REMARKS

The present application was filed on April 6, 2000 with claims 1-38. Claims 1, 13, 23 and 31 are the independent claims.

FIG.1B

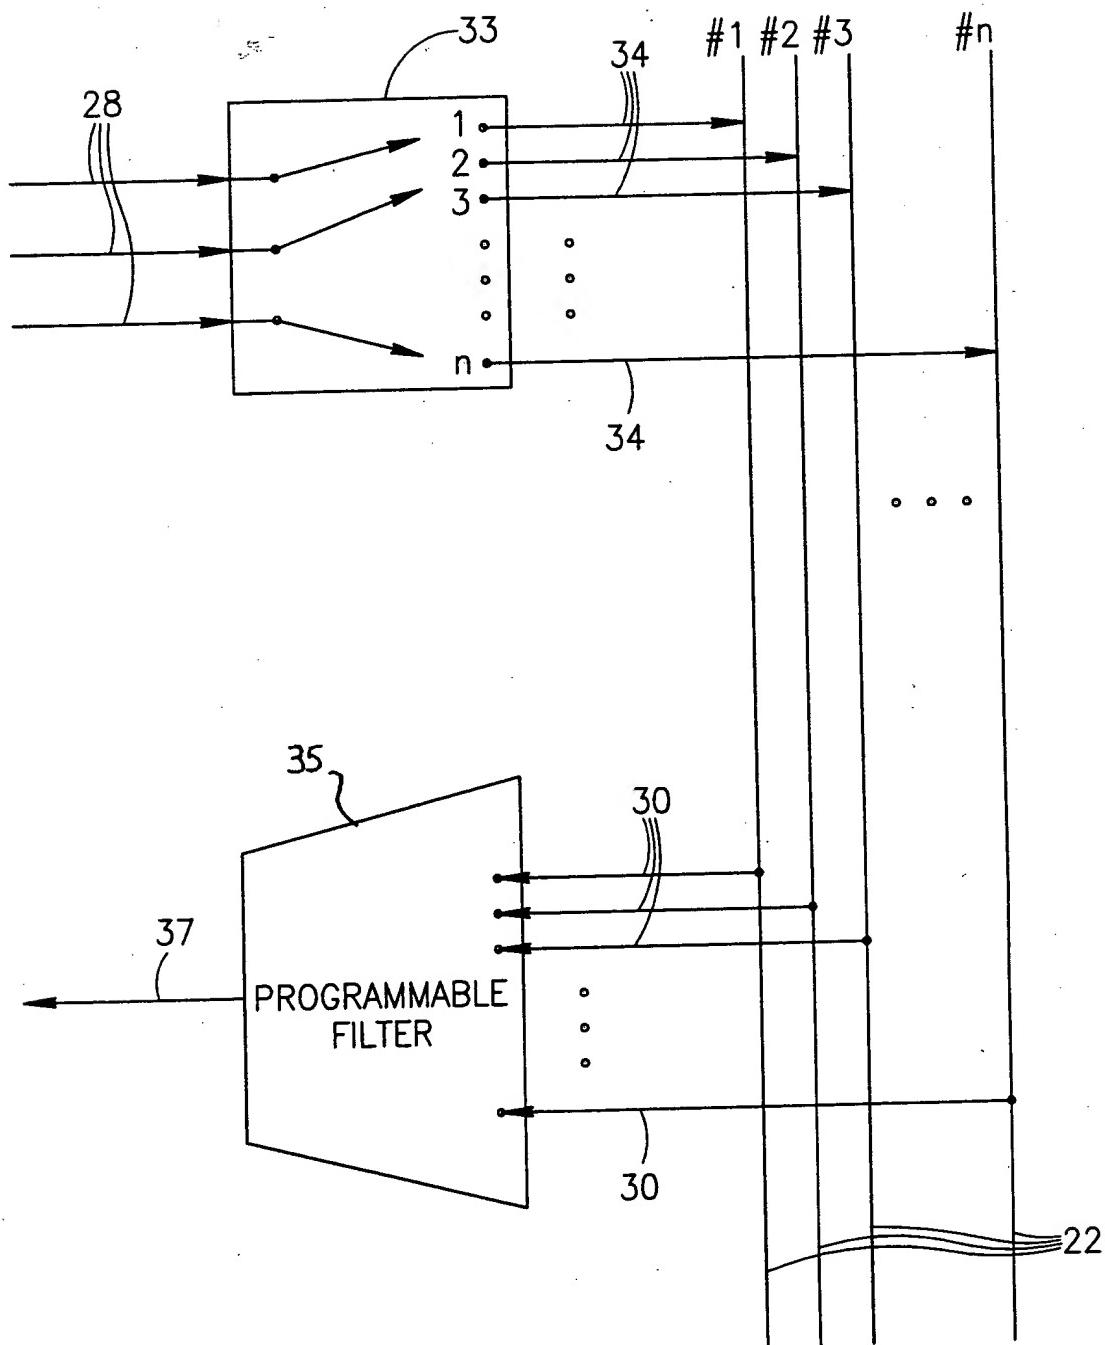
In the Office Action, the drawings were objected to on a number of grounds. In response, Applicants submit herewith a proposed red-lined drawing change to FIGS. 1A, 1B and 3. It is believed that the proposed changes to the drawings address the objections raised by the Examiner. Accordingly, withdrawal of this objection is respectfully requested.
